MEMORANDUM

Subject: Site Plan Correction at 3002 Scenic Drive
File No. SP-01-0251DS

Subject: Construction of Bordelon dock at 2910 Edgewater Drive
File No. SP-03-0176DS

Austin Clean Water Program
Upper Tannehill – Broadmoor and Cameron Project

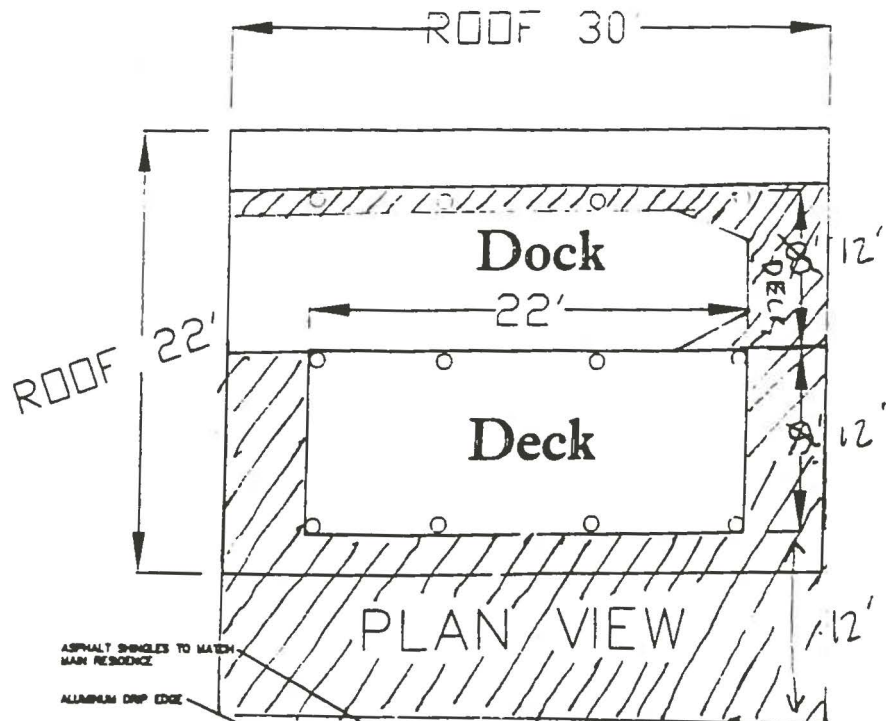
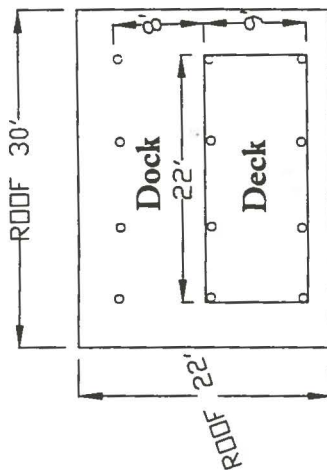
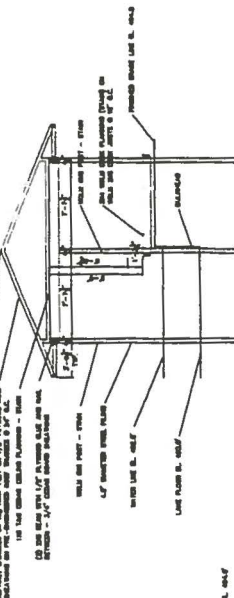
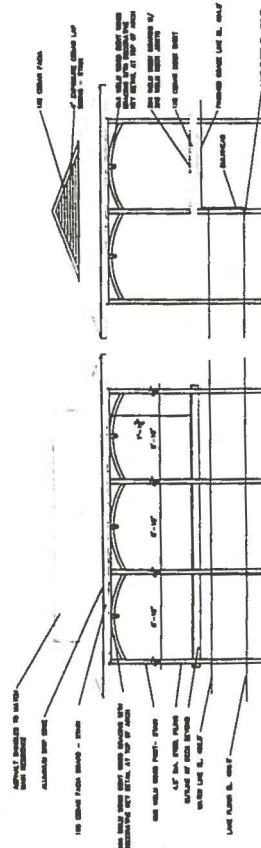
A site plan correction has been received from Bruce Aupperle on the behalf of Jerry and Johnstone Bell to change the dimensions and position of a boat dock that has been constructed and red tagged at 3002 Scenic Drive. The dock was built not in accordance to the approved site plan.

The Parks and Recreation Department (PARC) staff has reviewed the site plan correction and finds they do not meet the requirements of Article XIII, Section 25-2-1176, Parts B and D, (Requirements for the Construction of Boat Docks) of the Land Development Code. Parks and Recreation Board approved an 8'X22' boat dock placed parallel to the shore. Parks and Recreation Board gave variances for this dock to be constructed. The dock that was built is 12'X30'. The 30' measured parallel to the shoreline is 39% of the shoreline frontage. The approved 22' was 29% of the shoreline frontage. The approved dock was to be dug into the shore 3' and extend 5' from the original shore. If the dock were dug into the shore, the dock would have extended into the slough 20% of the sloughs width. The dock was not dug into shore and extends 12' from shore. The dock is now 43% of the slough width.

The Parks and Recreation Board shall make a recommendation on the distance a dock may extend into the slough and approval by the Parks and Recreation Board is required for a structure to be greater than 20% of the shoreline width.

= NOT APPROVED

BOAT DOCK DETAIL
SCALE = 1:10

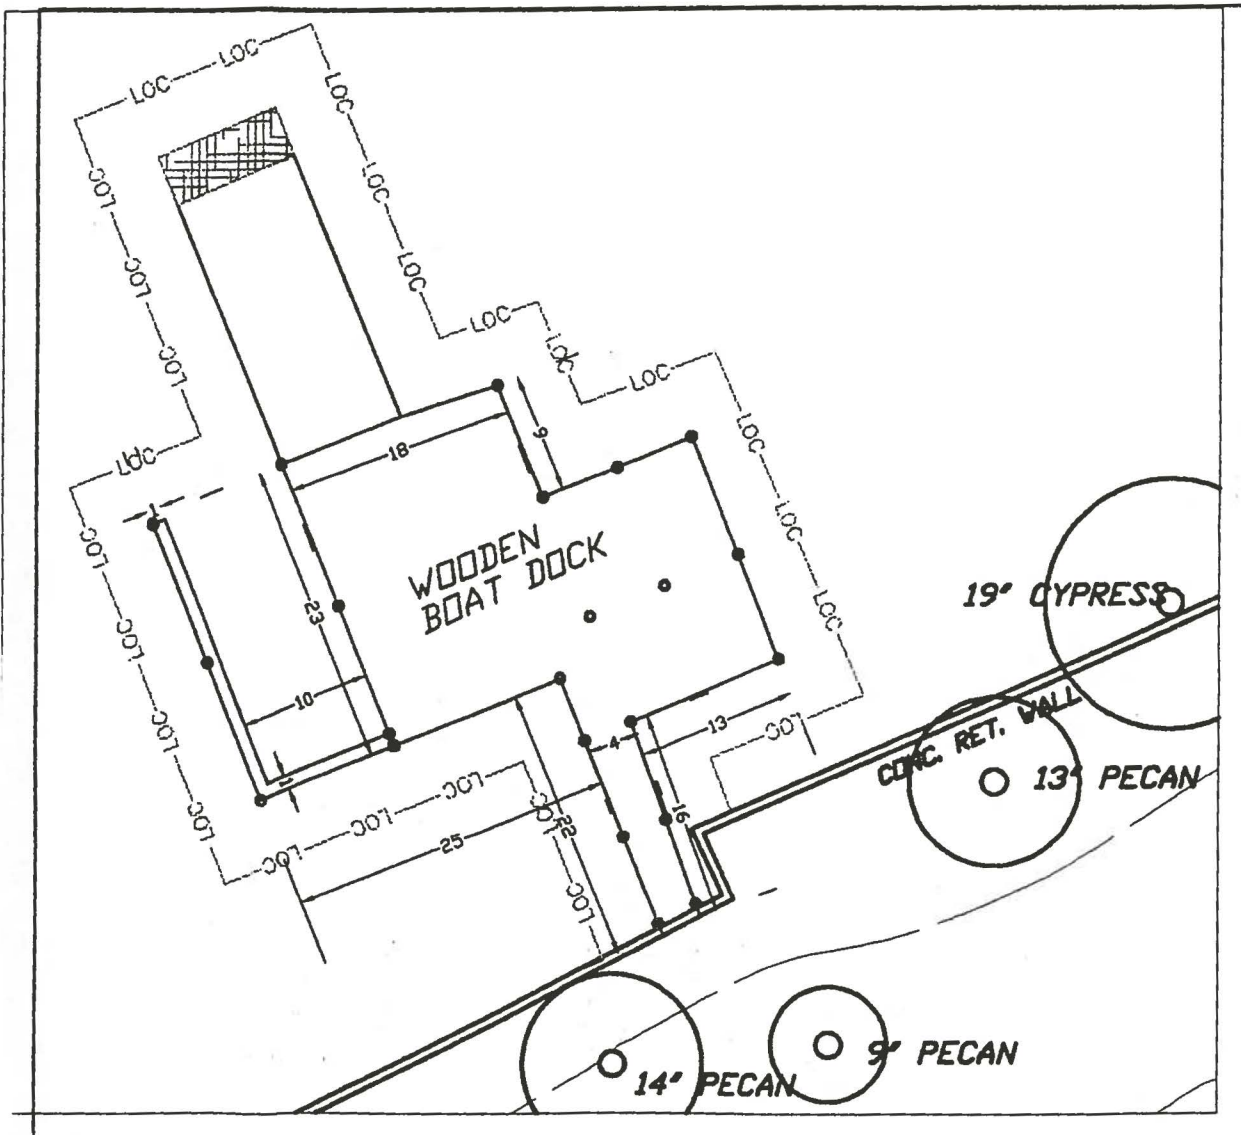
The Parks and Recreation Department (PARD) staff has reviewed plans for the proposed project and finds they do not meet the requirements of Article XIII, Section 25-2-1176, Parts B and D, (Requirements for the Construction of Boat Docks) of the Land Development Code. The proposed dock extends into the lake more than 30' and has a width greater than 20% of the shoreline frontage.

The Parks and Recreation Board shall make a recommendation on the distance a dock may extend into the lake and approval by the Parks and Recreation Board is required for a structure to be greater than 20% of the shoreline width.
